PROPOSAL FOR DRAFT AMENDMENTS TO REGULATION No. 58

- I. Rear Underrun Protection Devices (RUPDs)
- II. Vehicles with regard to the Installation of an RUPD of an approved type
- III. Vehicles with regard to their Rear Underrun Protection (RUP)

Note: The text reproduced below was prepared by the expert from OICA as a preliminary comment to the proposal from Germany to amend the Regulation No.58 (document GRSG-102-26). The modifications to the current text of the Regulation are marked in **bold** for new characters and ~~strike through~~ for deleted characters.

Figure 1

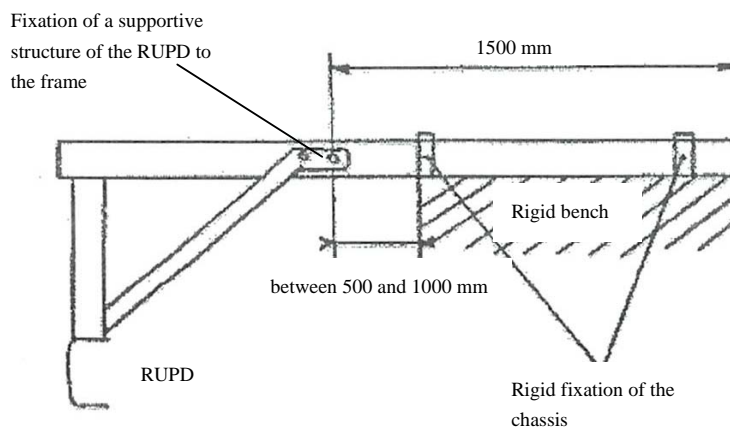
The Figure 1, if not improved, should represent only the minimum requirements to be fulfilled, and this should be mentioned in the text of item 1.1.3. It is considered appropriate that the Technical Services have the necessary information to reproduce the test bench.

“1.1.3. On a rigid test bench (see figure 1, representing the minimum requirements to be fulfilled).
